5.0 Reactor Coolant System and Connected Systems

5.1 Summary Description

The information in this section of the reference ABWR DCD, including all subsections and figures, as modified by the STP Nuclear Operating Company Application to Amend the Design Certification rule for the U.S. Advanced Boiling Water Reactor (ABWR), "ABWR STP Aircraft Impact Assessment (AIA) Amendment Revision 3," dated September 23, 2010 is incorporated by reference with the following departures.

Figure 5.1-1 Rated Operating Conditions of the ABWR

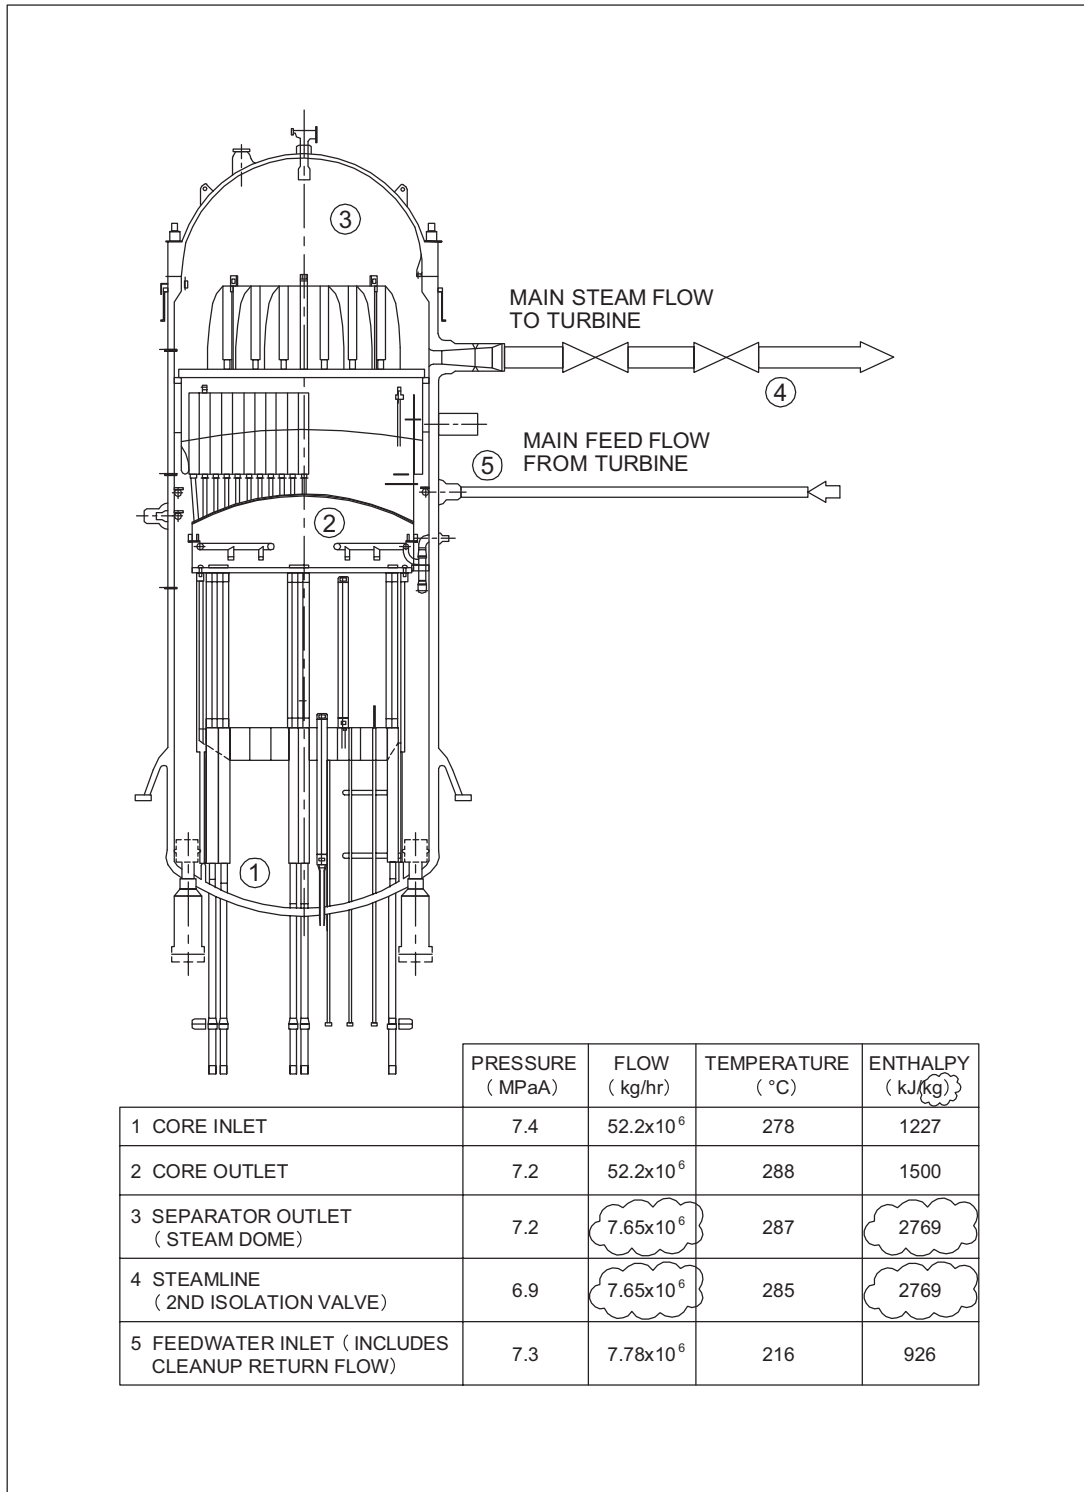
STP DEP 10.1-3 (Figure 5.1-1)
